**REQUEST**

Current Zoning: R-3 (single family residential)  
Proposed Zoning: UR-2(CD) (urban residential, conditional)

**SUMMARY OF PETITION**

The petition proposes redevelopment of the existing institutional use with a residential development containing up to 38 single family attached townhomes east of the Park Road Shopping Center.

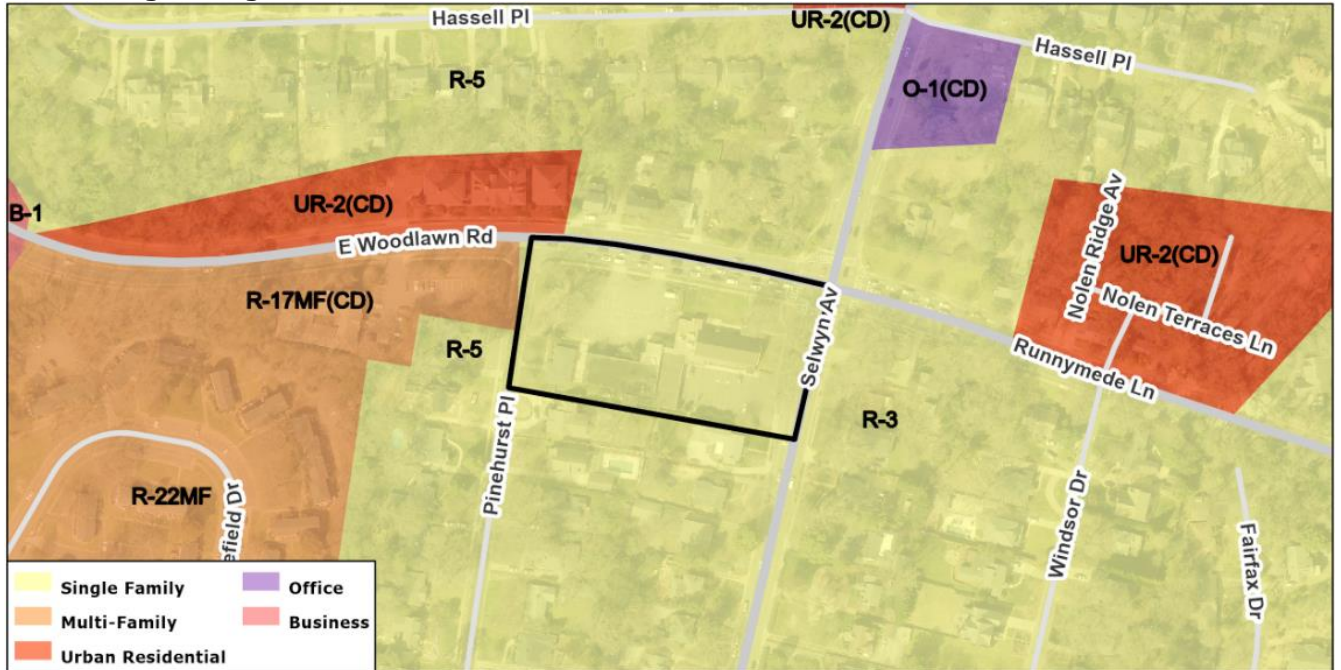
1. ~~Provide buffer and height plane cross-sections on the rezoning plan.~~ Addressed
2. ~~Provide a landscaped area at least 10 feet wide along the southern property line.~~ Addressed.

3. ~~Limit the height of the southern most units, nearest to single family homes, to 40 feet.~~ Addressed
4. ~~Amend the plan to provide at least 8 internal visitor parking places.~~ Addressed, the petitioner has noted that the intent is to provide private rollout collection and confirmed with Solid Waste Services that 2 parking spaces can be provided within potential dumpster location.

5. ~~Verify with Solid Waste that proposed location will work for trucks and Amend the site plan to provide detail for the potential dumpster locations. The areas shall have space for 4yd dumpsters on wheels that can be rolled out in front of the truck and serviced internal to the site.~~ Addressed

6. ~~Amend Architectural standards note 4. that corner/end units that face a public or private street will have a porch or stoop that wraps a portion of the front and side of the unit OR add a note to provide blank wall provisions that limit the maximum blank wall expanse to 10 feet on all building levels.~~ Addressed

7. ~~Revise site plan and conditional note(s) to commit to dedicate 50' minimum right of way from the road centerline on East Woodlawn Road and Selwyn Avenue. The site plan shall label and dimension the right of way as 50' minimum from each road centerline.~~ Addressed
8. ~~Place the sidewalk utility easements along Pinchurst Place 2 feet behind the back of sidewalk. No SUE required on Woodlawn if sidewalk is fully within the dedicated right of way.~~ Addressed

9. ~~Amend Architectural note 6 to say that dwelling units will be limited to a maximum of 3 per building when facing a public street.~~
10. ~~Amend Architectural note 11 to say that "The Height Exhibits and Exterior Elevation Renderings depicted on the Rezoning Plan are schematic in nature and are intended to depict the general arrangement of such building elements and improvements on the Site. They may be altered or modified in accordance with the requirements set forth on this Rezoning Plan and Section 6.207 of the Zoning Ordinance."~~
11. ~~Add a note clarifying that each unit will have a two-car garage.~~
